ADDENDUM NO. 2

Issue Date:	January 17, 2024
Project Name:	Sandridge Golf Club New Clubhouse
ITB Number:	2024029
ITB Opening Date:	**February 1, 2024**

This addendum is being released to provide answers to questions received to date, modify the bid documents, provide additional background documents, and provide minutes to the pre-bid meeting.

SHEET NUMBER
I217

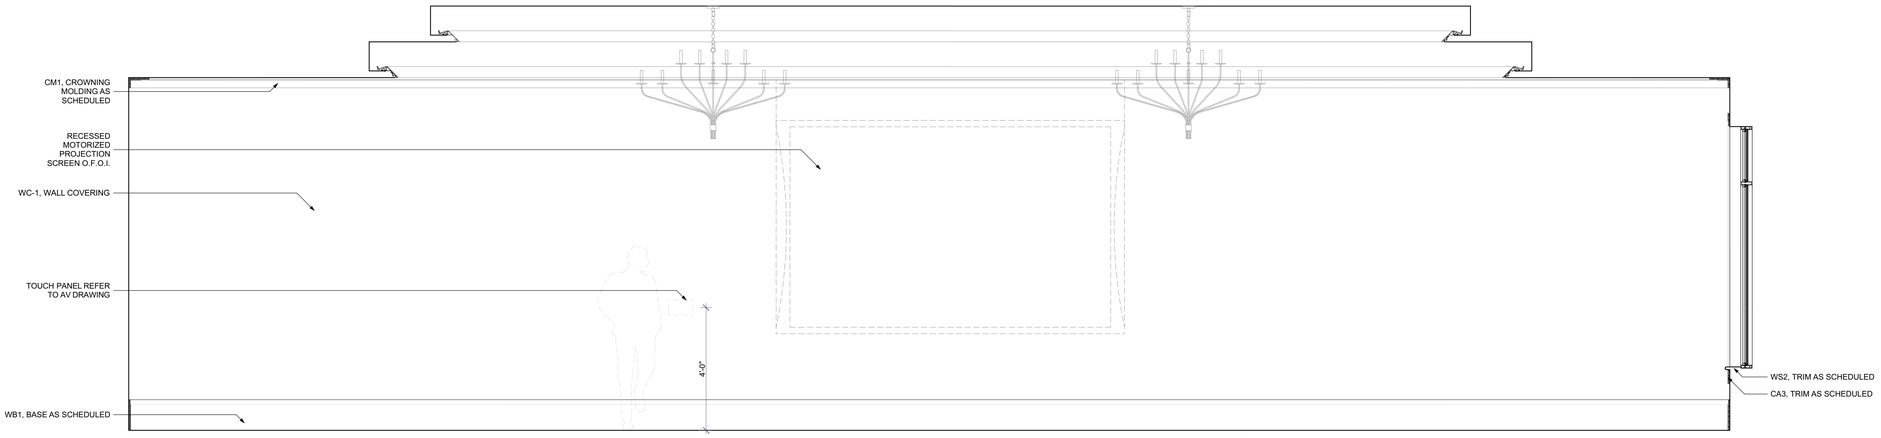
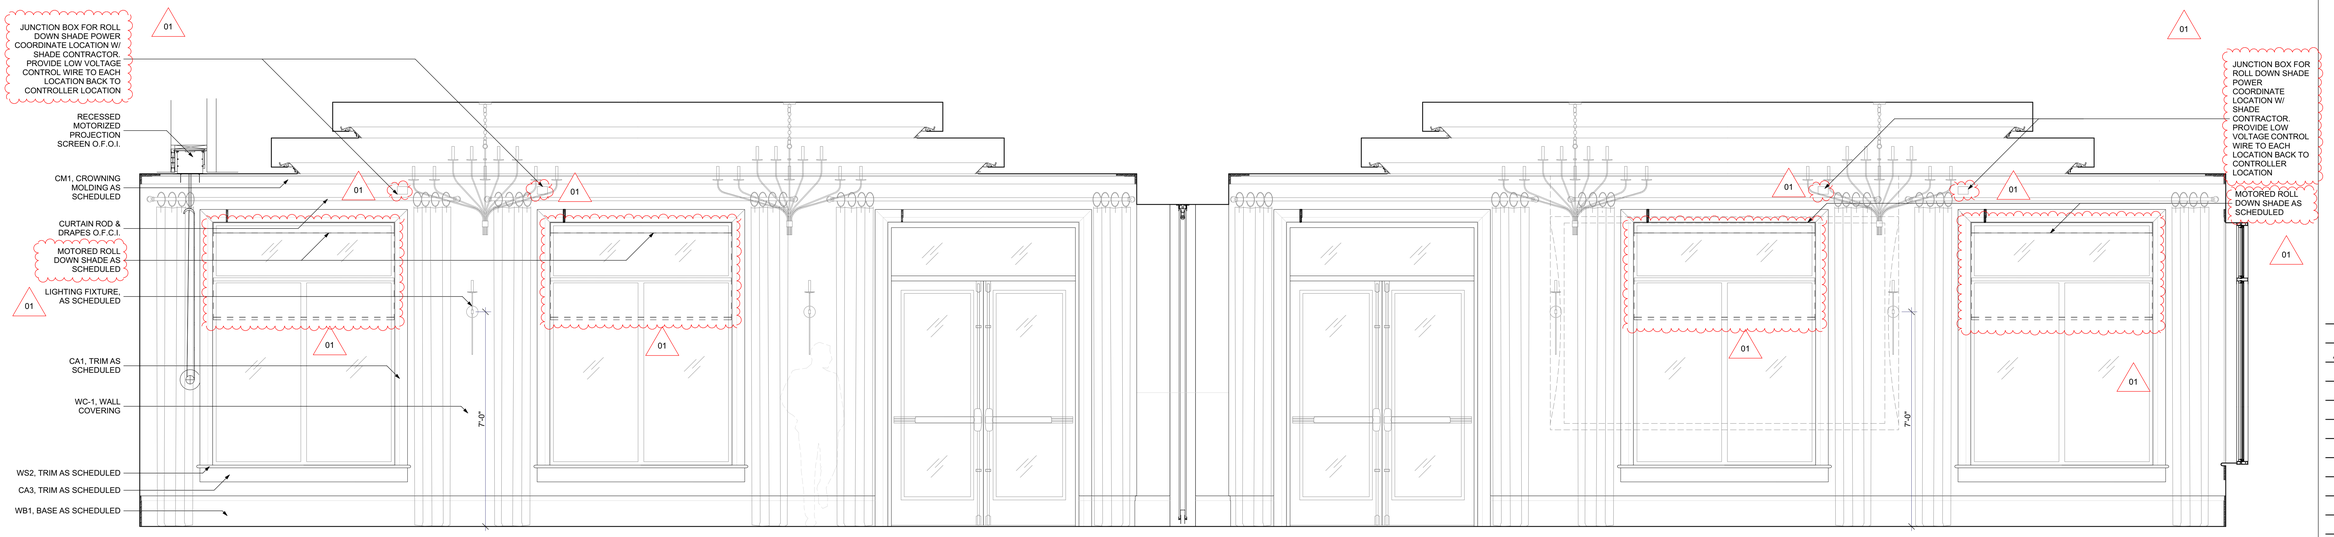
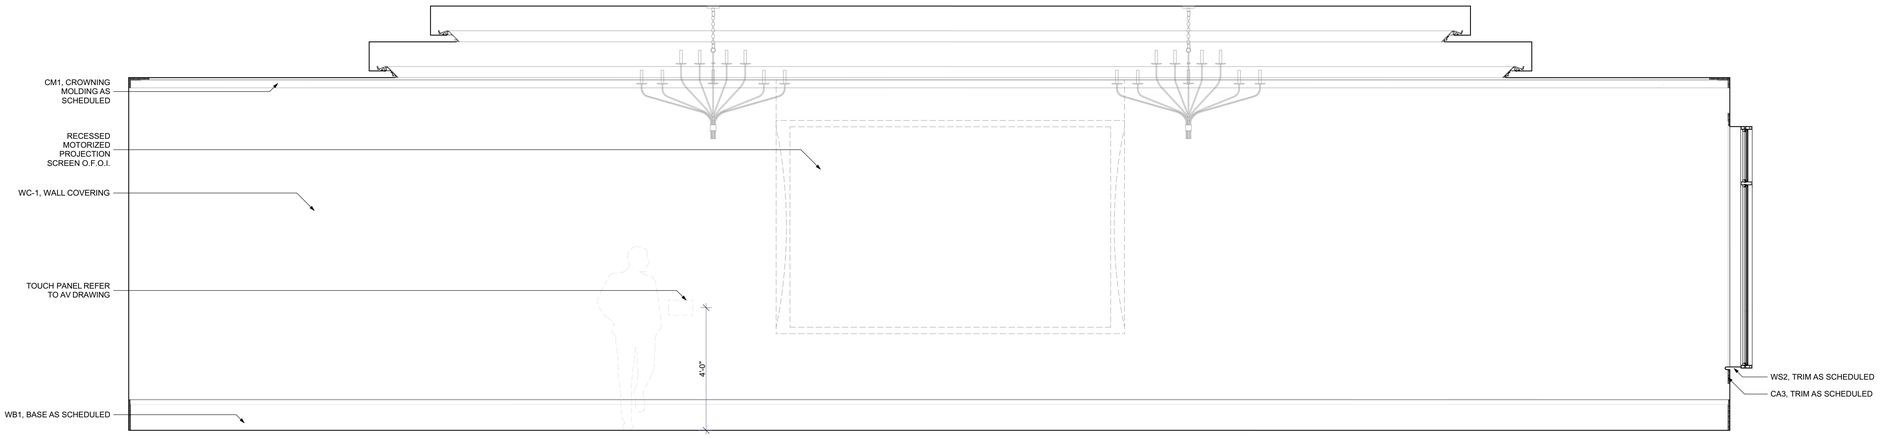
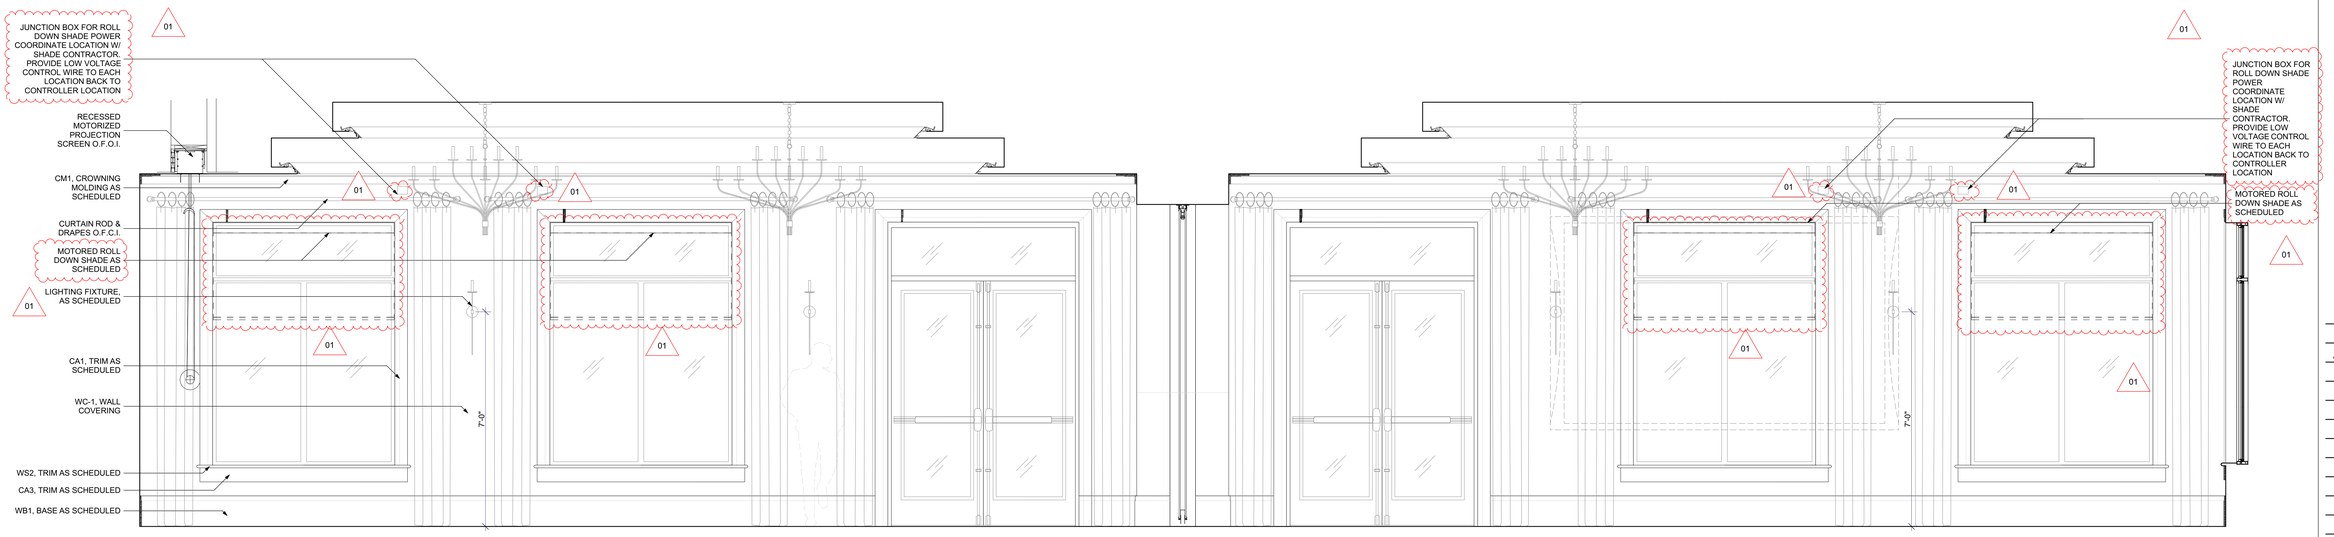
15. PLEASE CONFIRM THE ROLL DOWN MOTORIZED SCREENS ARE BY OWNER.
Roll down motorized screens are contractor furnished/contractor installed. See revised sheets A411, A605, A805, I216 and I217 for additional information.
